Agenda Item **No. 5(b)**
Meeting of December 5, 2017

SUBJECT: Conditionally approving the schematic design for an affordable housing and retail mixed-use building at Candlestick Point North Block 10a, consisting of approximately 156 affordable family rental units, including 35 units set aside for formerly homeless families; and adopting environmental review findings pursuant to CEQA; Bayview Hunters Point Redevelopment Area

CANDLESTICK POINT NORTH

BLOCK 10A

ENTRY DETAILS
MAIN RESIDENTIAL ENTRY

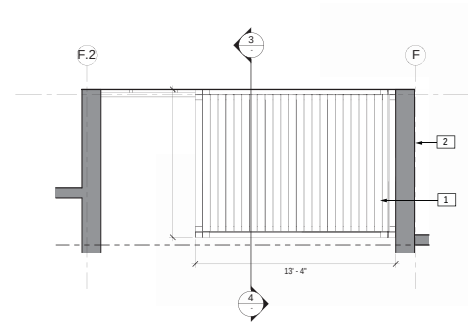
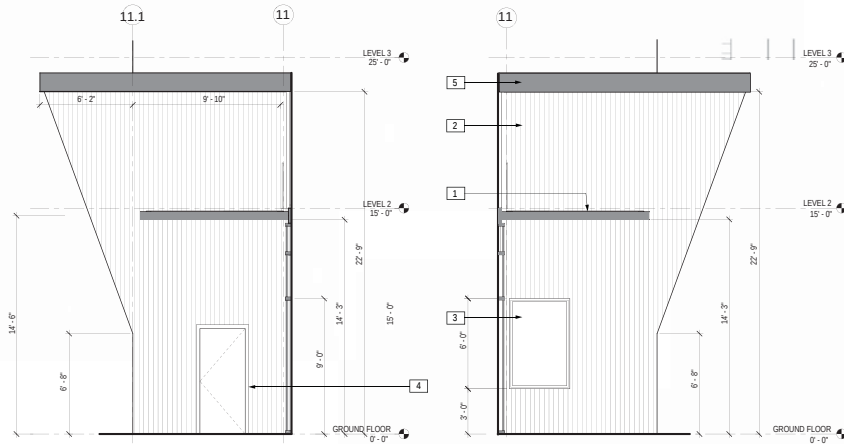
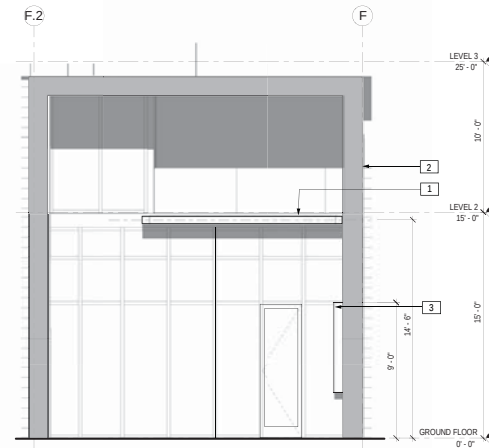
11. Stained wood Parklex cladding at lobby entrance. Consider a more durable material, such as a cement pedestal, at the ground-level impact zone (up to 16 inches from grade), as the lobby entrance will be a high-traffic space, and the ongoing replacement cost may offset the higher up-front cost.

16. Residential Lobby Stair and Angled Wall. Remove the slight angle from the lobby stairwell and adjacent walls; the angle is too slight to serve any design intent and will only increase costs.

3 AXONOMETRIC VIEW OF TYPICAL RETAIL CANOPY
3/8" = 1'-0"

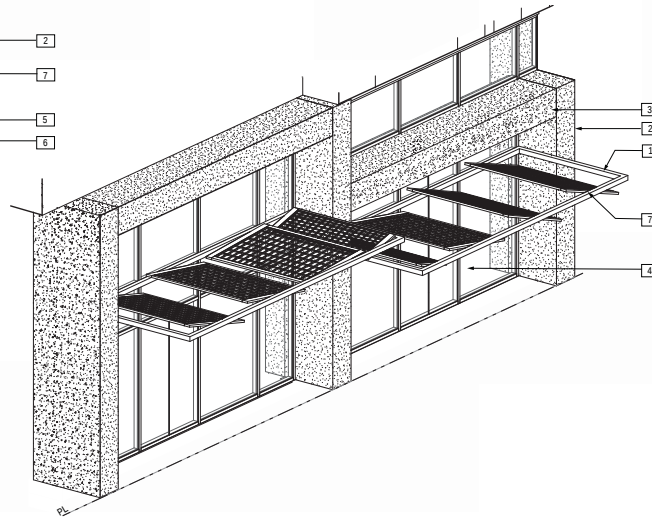
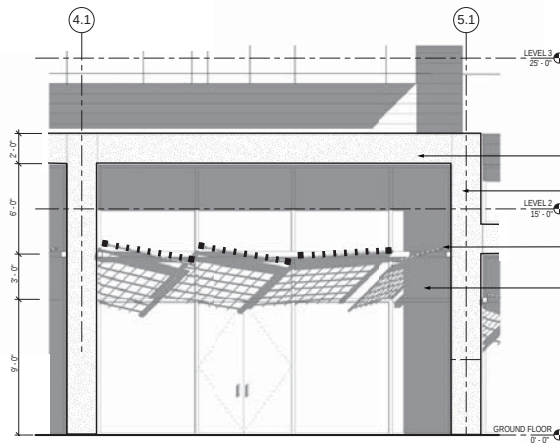
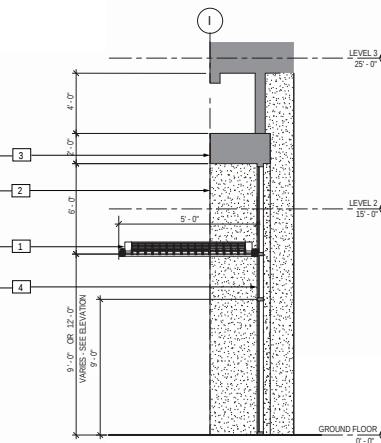
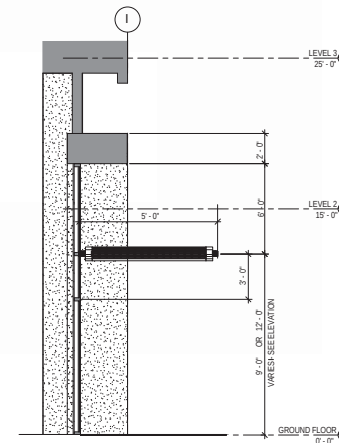
6. Retail kinetic steel awnings

- a. Please study a low-iron glass for the retail storefront.
- b. Installation and maintenance of awnings to be paid for and maintained by retail tenants during Tenant Improvement phase.
- c. Increase vertical clearance to be greater than 9 feet where proposed – while this complies with the minimum projection clearance, the ground-floor height along Ingerson should feature a consistent floorline datum and maximize visibility into retail spaces.

SOLAR CANOPY
SOLAR CANOPY DESIGN CONCEPT

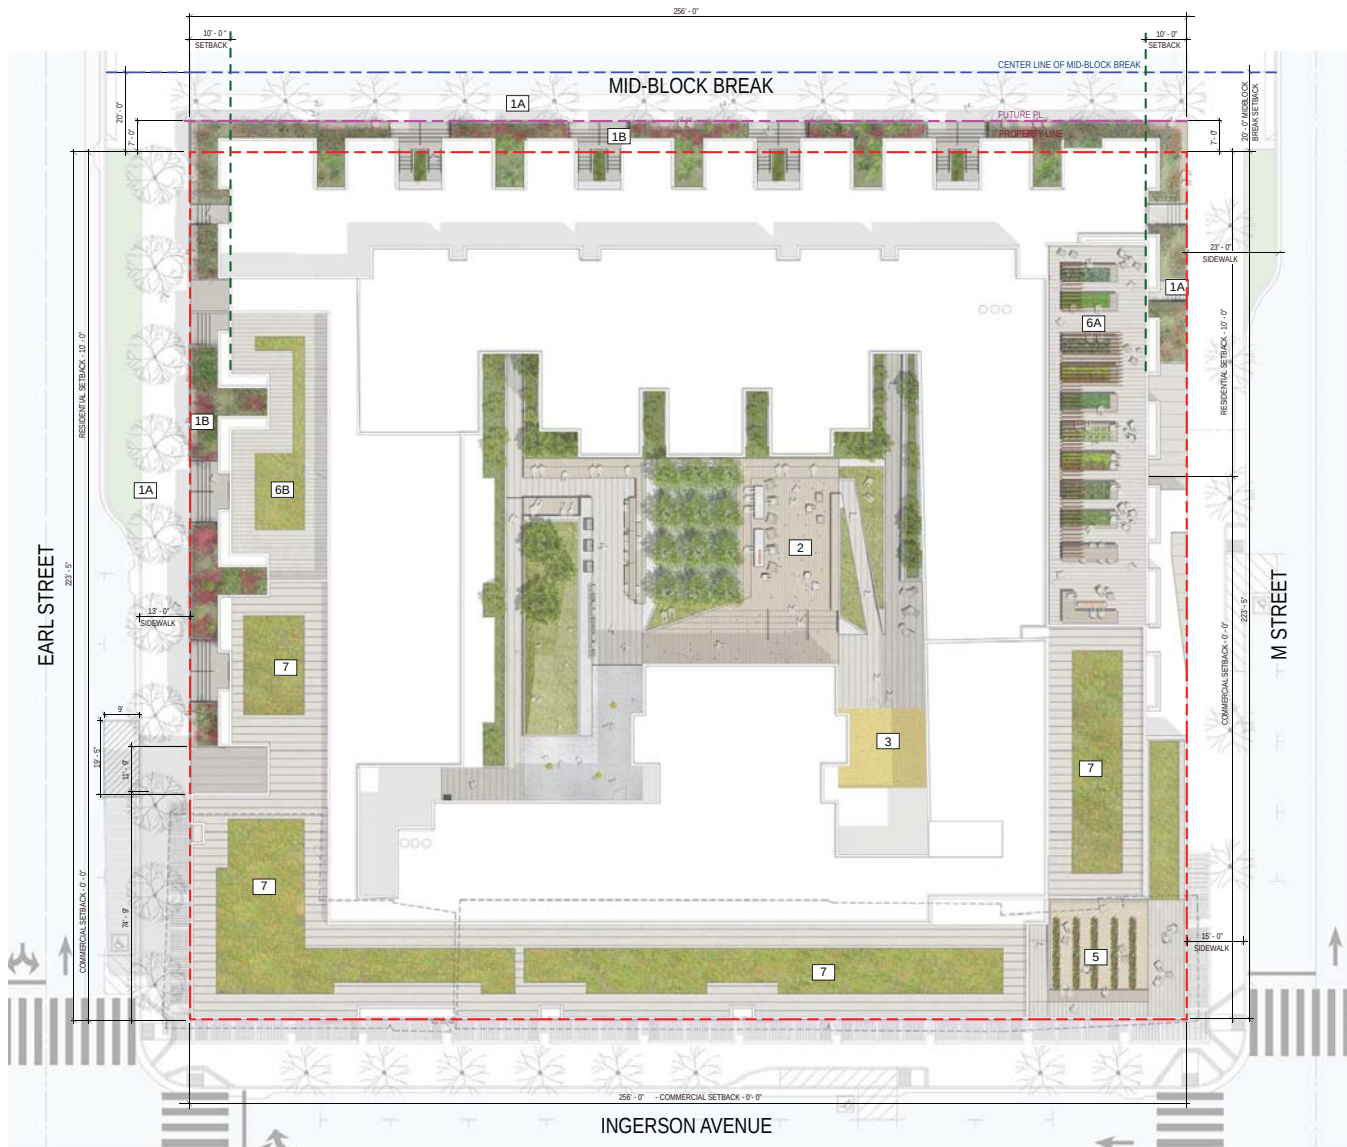
4. PV Canopy Structure

- a. If the PV Canopy is eliminated from the design, or is changed as a cost reduction measure after Schematic Design approval, OCII staff must approve the parapet geometry, roofline articulation, rooftop plan and any mechanical screening, or the altered PV canopy as they differ from the approved Schematic Design. The roofline should be articulated to reinforce its role as the top of the building and should form an integral part of the overall building composition. Expressive and sculptural roof forms that will be seen from a distance are encouraged. Wherever possible, roof mechanical exhaust vent and equipment projections should be clustered and set back from the edge of buildings that are visible from the street or points above.
- b. If the PV canopy is eliminated from the design, the project shall provide 'solar ready' infrastructure per the D for D.
